Re: Armored Cap Enhancement Work Plan
San Jacinto River Waste Pits Superfund Site Time Critical Removal Action United
States Environmental Protection Agency, Region 6, CERCLA Docket No. 06-12-10

Project Number: 090557-01

USACE CONCLUSIONS AND ANCHOR QEA RESPONSES

Re: San Jacinto River Waste Pits Superfund Site Time Critical Removal Action
Response to USEPA Questions on TCRA Cap Assessment
CERCLA Docket No. 06-12-10

Attachments: Figure 1 – Armored Cap Enhancement Plan
Letter dated June 14, 2013

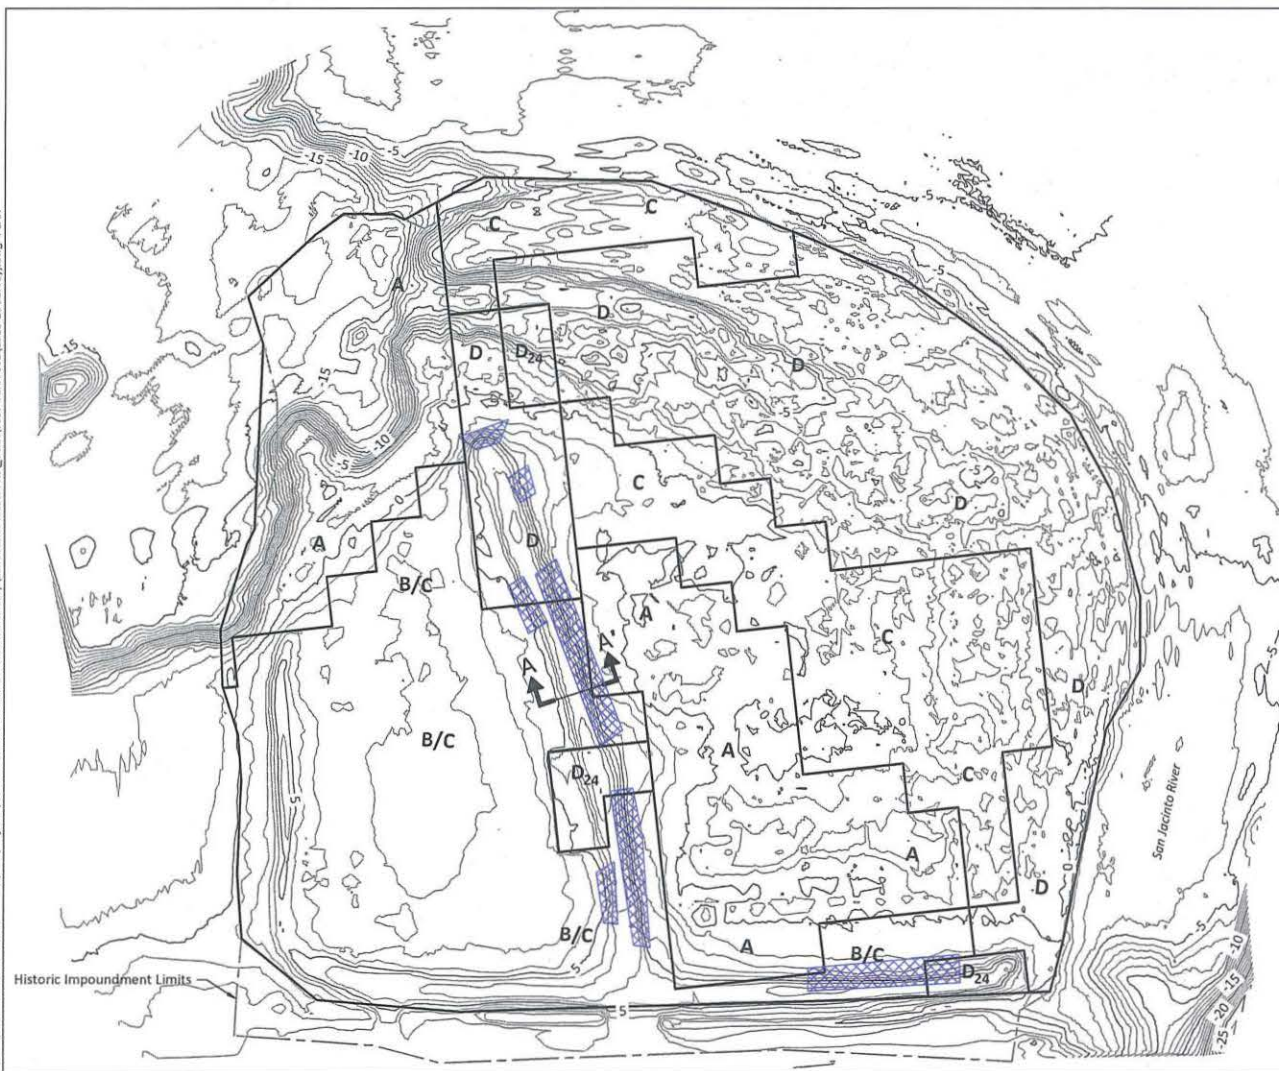
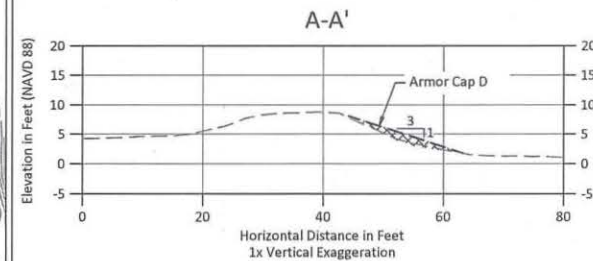
4. *Repair should ensure that the final surface throughout the repair area and adjacent areas has a slope of 1V:3H or flatter.*

Using the October 2013 quarterly inspection survey data, Anchor QEA has delineated areas that have slopes steeper than 1V:3H within the wave runup or surf zone of the TCRA armored cap. As shown in Figure 1, seven discrete areas have been identified. The Respondents will reduce the slopes of the seven areas to 1V:3H with stockpiled Armor Cap D rock. The use of D rock to reduce the slopes was modeled for and discussed in the Draft FS (Appendix B). As described in Appendix B of the Draft FS, the D rock ($D_{50}=10$ inches, $D_{85}/D_{15}=1.55$) exceeds the computed Maynard equation D_{50} particle size (Anchor 2013) and has a larger D_{50} than the C rock. The Armor Cap D rock also has a uniformity coefficient that falls within the recommended range provided by the Transportation Research Board (NCHRP 2006). The use of Armor Cap D rock provides an increased level of stability, a factor of safety of 1.5, and addresses the enhancement outlined in the USACE's report. The proposed construction requirements, construction schedule, and QA/QC procedures, and plans for the continued implementation of the OMM Plan, are described below.

Response: The Work Plan proposes to add Armor Cap D rock as necessary to reduce existing slopes to 1V:3H. The details of the proposed activities are described in the Armored Cap Enhancement Plan section below.

To reduce the slopes to 1V:3H or flatter, the contractor will transport the Armor Cap D rock from the stockpile and place the rock in the locations shown in Figure 1. Using a small loader (Bobcat, Skid Steer or equivalent equipment as appropriate), the contractor will transport and place the rock in a manner that prevents breakage of the rock. The contractor's survey crew will monitor the rock placement to confirm the required grades are met during construction. After the contractor has completed the rock installation, the areas will be re-surveyed to confirm the slopes are 1V:3H or flatter. The Armor Cap D stockpile is located approximately 15 miles away from the TCRA Site. The Armor Cap D rock meets or exceeds the TCRA original design requirements for each area of the armored cap. The Armor Cap D rock was purchased and stockpiled expressly for maintenance purposes and has already been tested and approved for gradation and chemistry.

Figure 1
Gradation of Armor Rock B/C
San Jacinto River Waste Pits Time Critical Removal Action

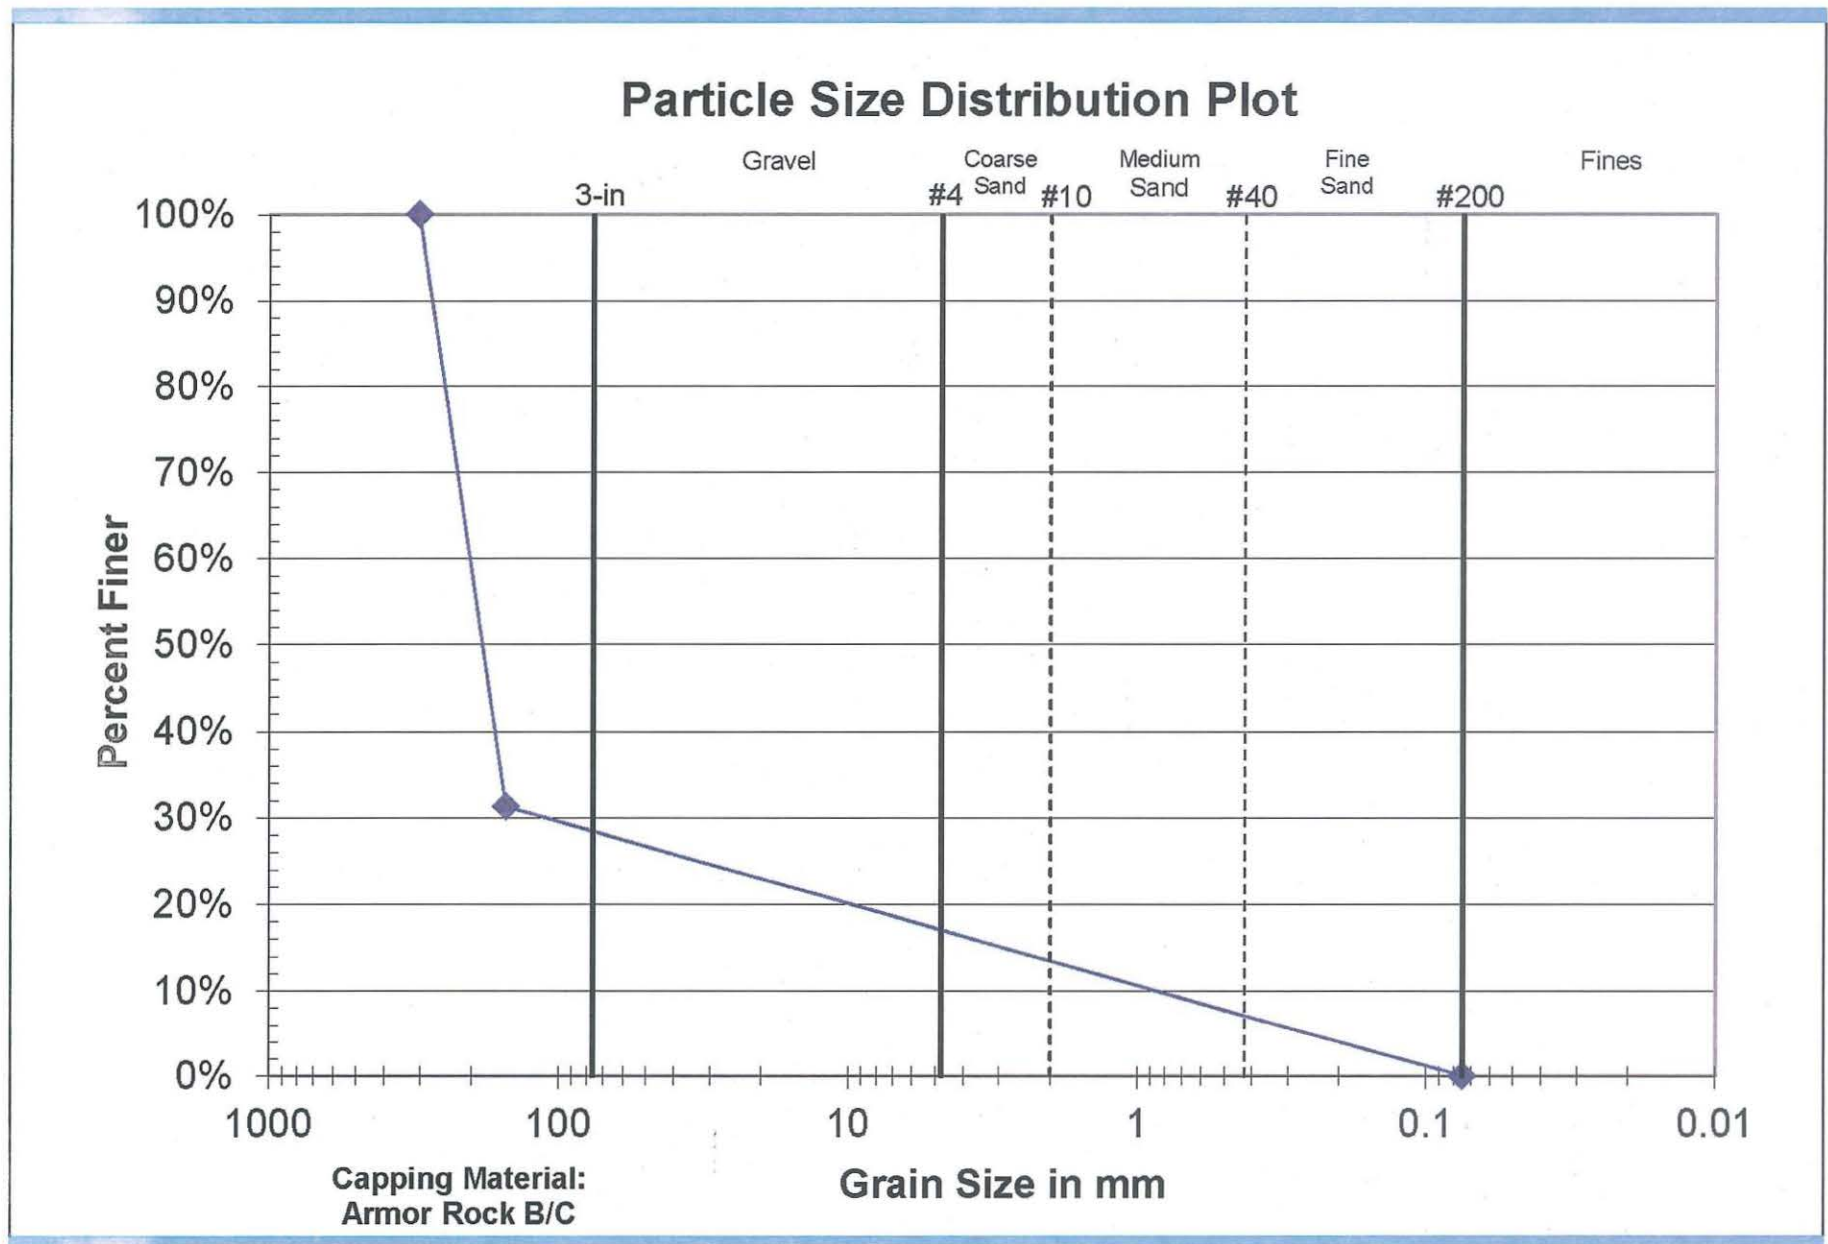
2. What is the measured or estimated grain size distribution for the B/C armor material? Specifically, what are the

- a. D_{100}
- b. D_{85}
- c. D_{60}
- d. D_{50}
- e. D_{15}
- f. D_{10}
- g. D_{30}

Using the contractor gradation submittal for the B/C armor material, the following is the measured and estimated grain size distribution for this material:

- D_{100} 12 inches
- D_{85} 9 inches
- D_{60} 8 inches
- D_{50} 6 inches
- D_{30} 4 inches
- D_{15} 0.12 inches
- D_{10} 0.033 inches

A grain size distribution curve for this material is attached for reference.
